**AGENDA**  
Regular Hybrid Meeting  
Town of Granby  
Planning & Zoning Commission  
Tuesday, July 22, 2025, at 7:00 pm  
Town Hall Meeting Room

**a. Application seeking a 7-lot subdivision, Breezy Meadow, for property located at 188 Day Street, R30 and R50 Zones: File P-1-25.**

### **Subdivision Application Plan Review**

Breezy Meadow Subdivision, Prepared for Peak Mountain Development, LLC, 188 Day Street, December 23, 2024, Sheets: SD-1, GR-1, GR-2 E&SC-1, E&SC-2, Notes-1, Alford Associates, Inc., last revised 7/15/25.”

## Day Street Streetscape

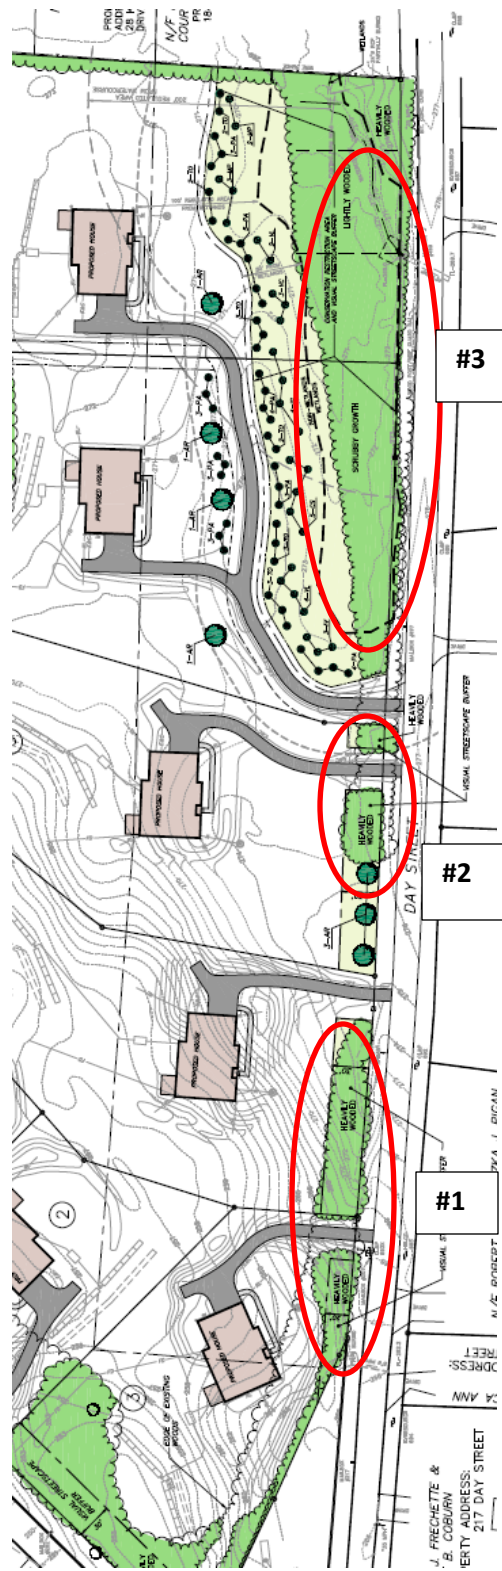
#1 View looking south: lots 3 and 4 behind wooded area

#2 View looking south: cleared area includes part of lot 4 where driveway is proposed and lot 5  
Tree/vegetated area is the “heavily wooded” area marked on lot 5 on VPPP-1

#3 View looking south: “scrubby growth area” marked on lots 6 and 7 on VPPP-1 (wetland area)

Sheet  
GR-1

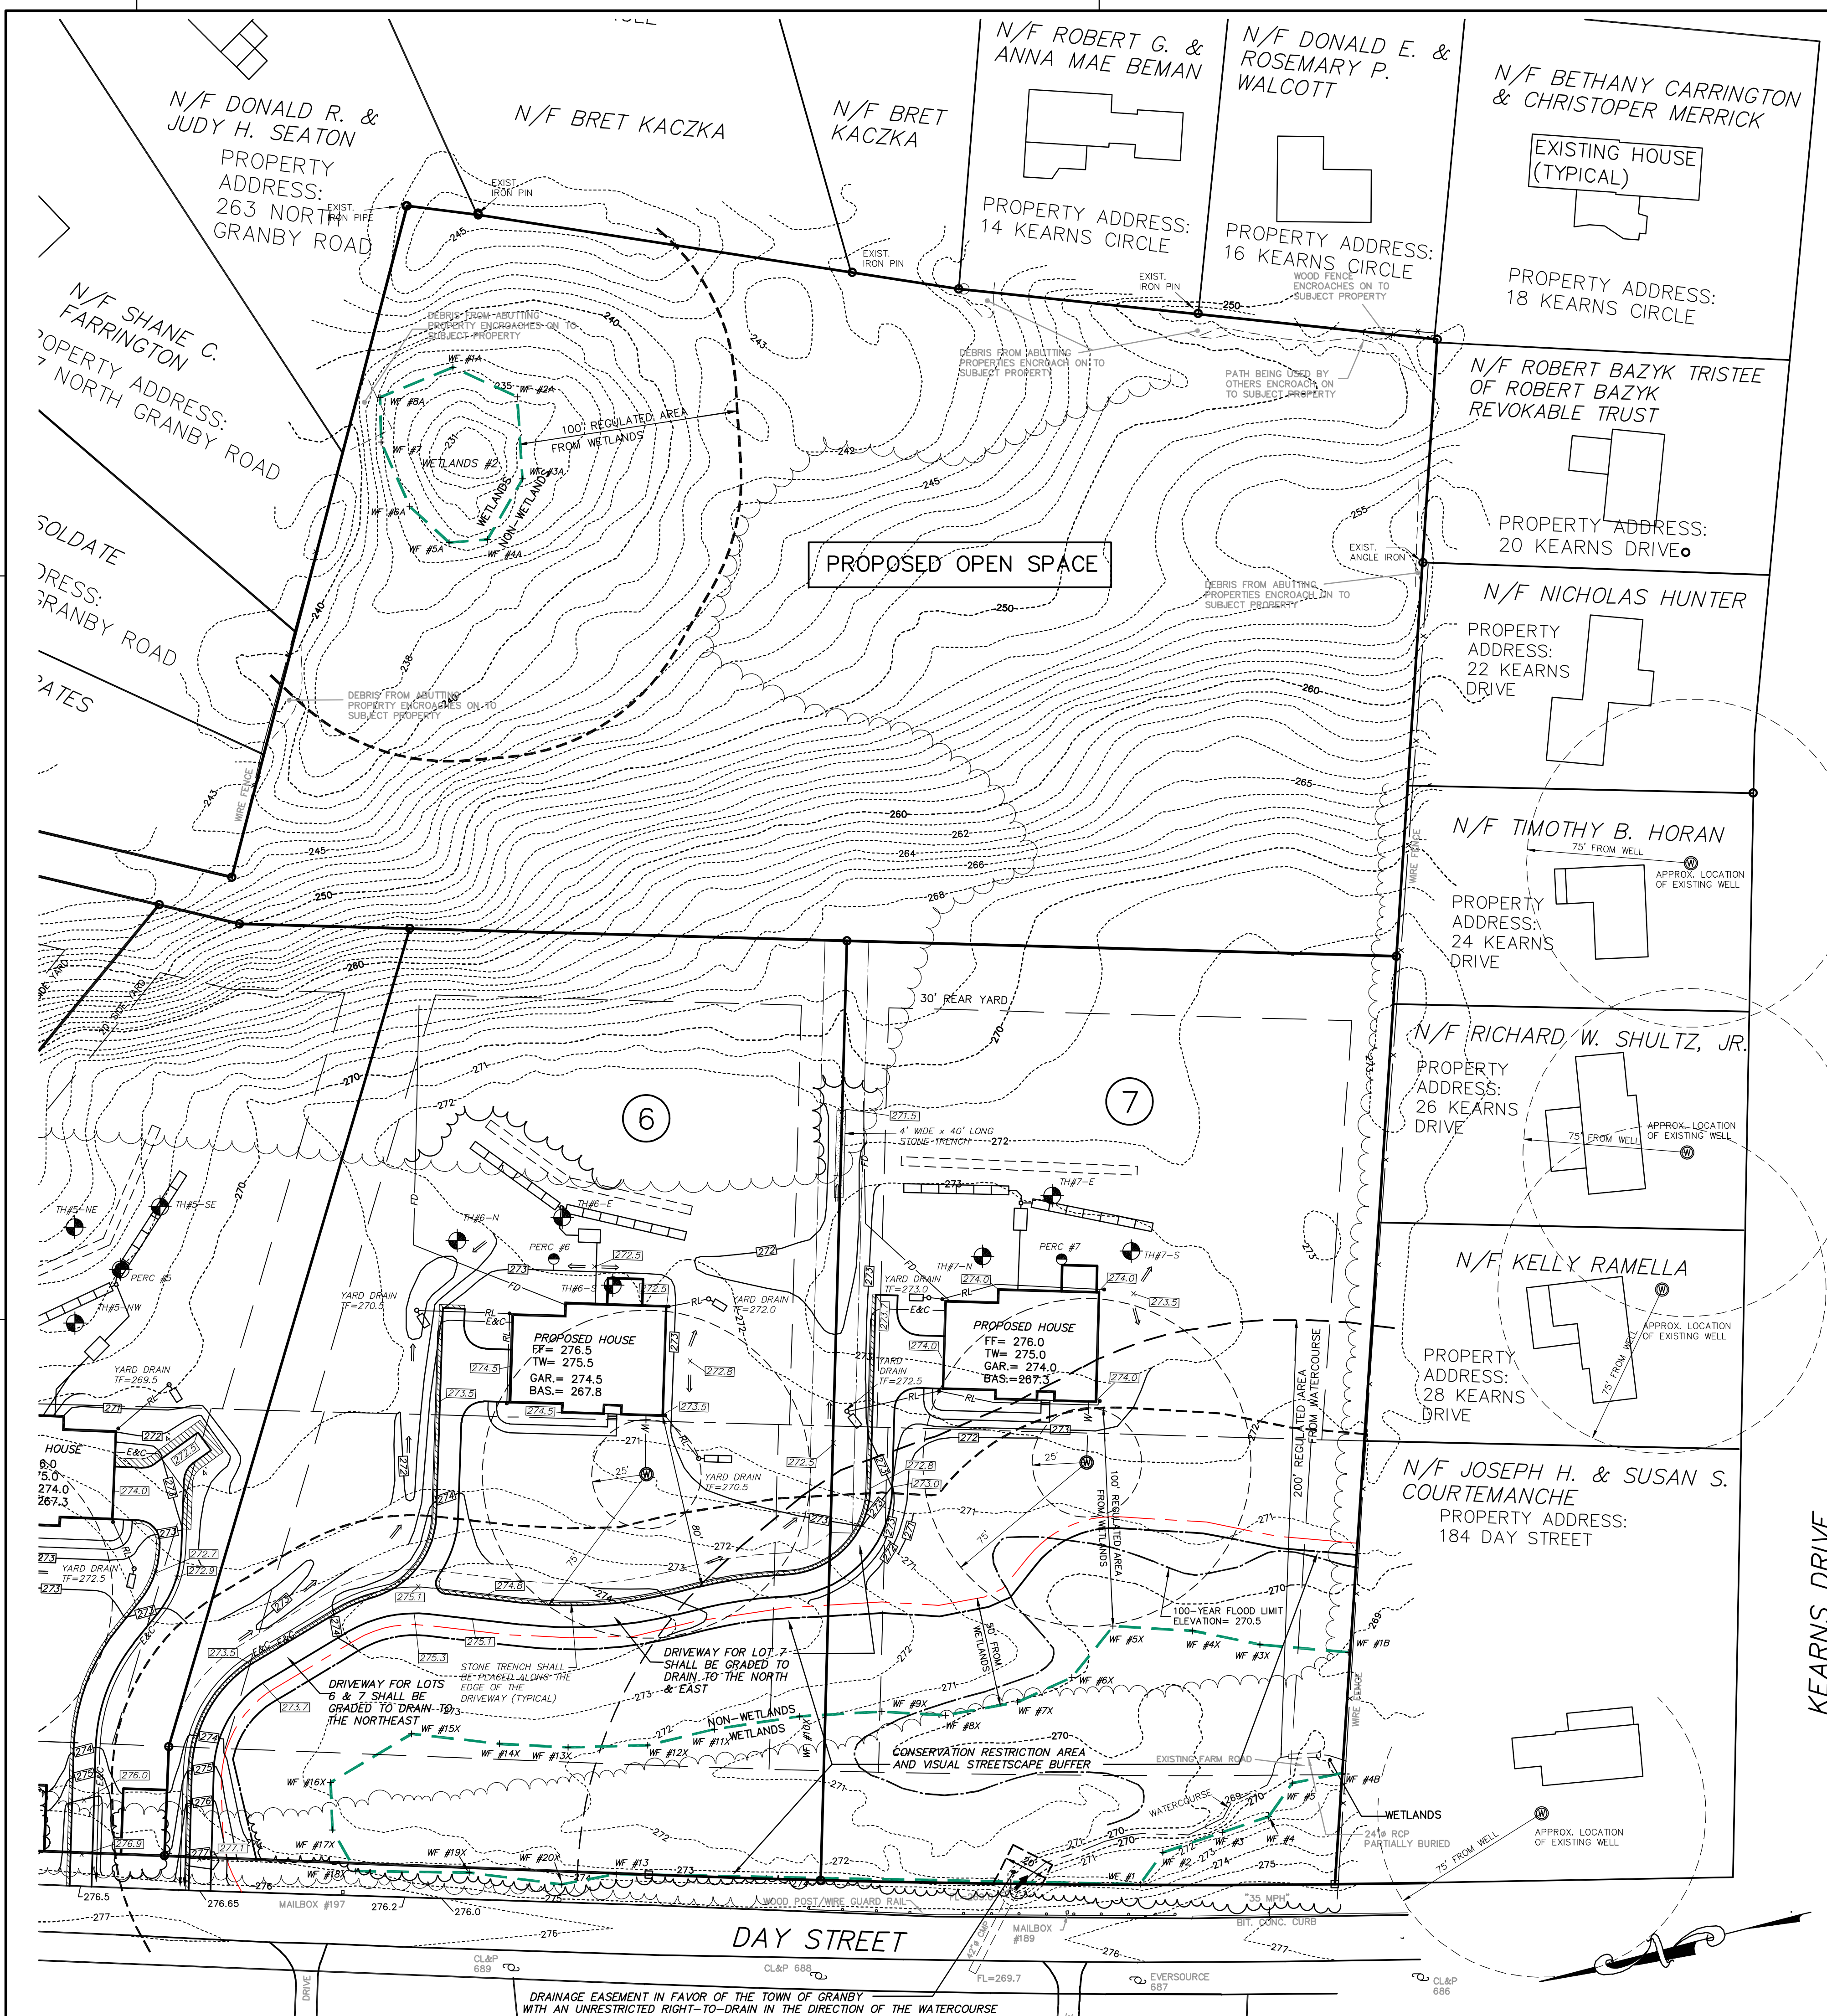
1. If possible, reduce the length of the swale on the west side of lot 3. Raising the house elevation may be beneficial. Long swales can be difficult for a homeowner to maintain.
2. Eliminate swale on north side of driveway to lot 6. Allow water to sheet drain across the lawn area.
3. Rain gardens (shallow basin at roof infiltration systems) still shown on the plans. Eliminate to allow for sheet drainage and remove from detail sheet.
4. Verify line-of-sight for driveway to Lot 3.
5. Plans to be revised as necessary to comply with FVHD letter dated 7/7/25. Resubmit to FVHD and submit final approval letter.

13. Reprint page 1 of the Hydraflow Report. The drainage schematic does not appear on the sheet.
14. Eliminate the rain garden/basins shown on lots 1,2,3,5, and 6. Stormwater from non-impervious areas should be allowed to sheet drain. Infiltration systems for the roof drains shall be sized according to the manufacturer's instructions. Soil test holes may be required at or in the vicinity of the infiltration areas if the excavation for the basements show a different soil profile.

Sheet  
VPPP-1

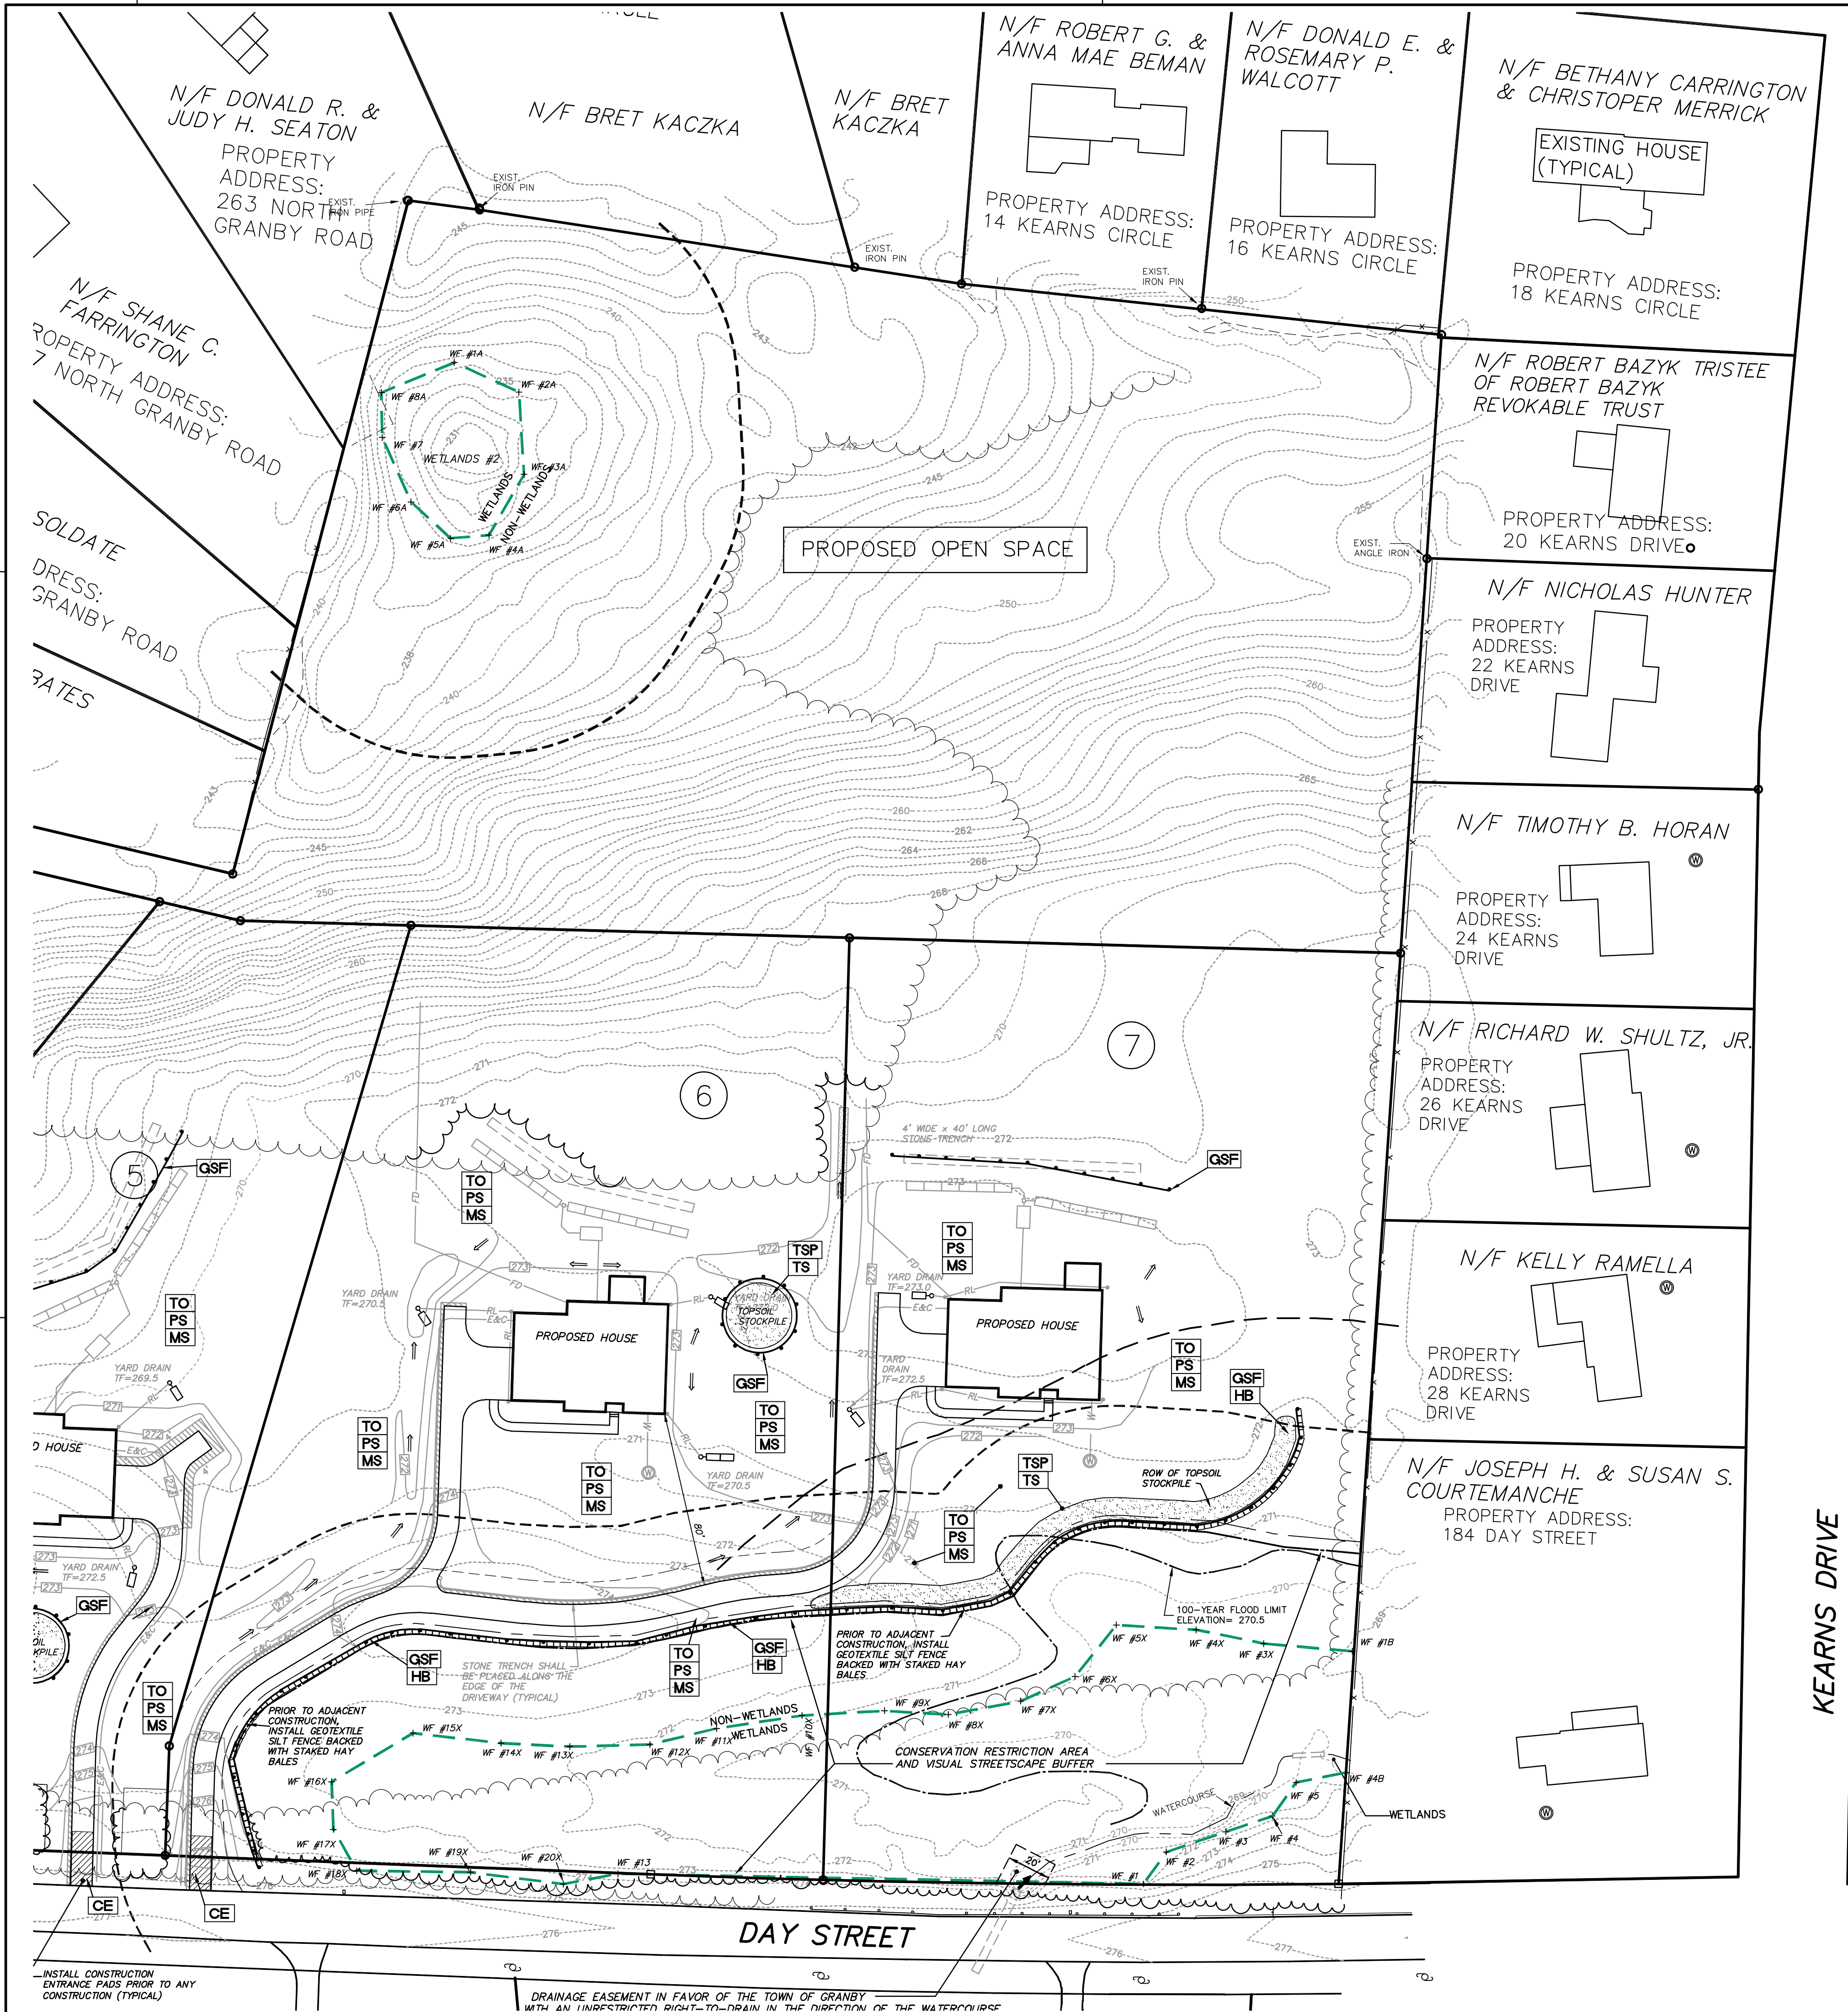
- 3. Sheet VPPP-1: The clearing area is color coded, which is helpful, but for the mylars, it should be labeled the vegetation to remain and what will be removed.
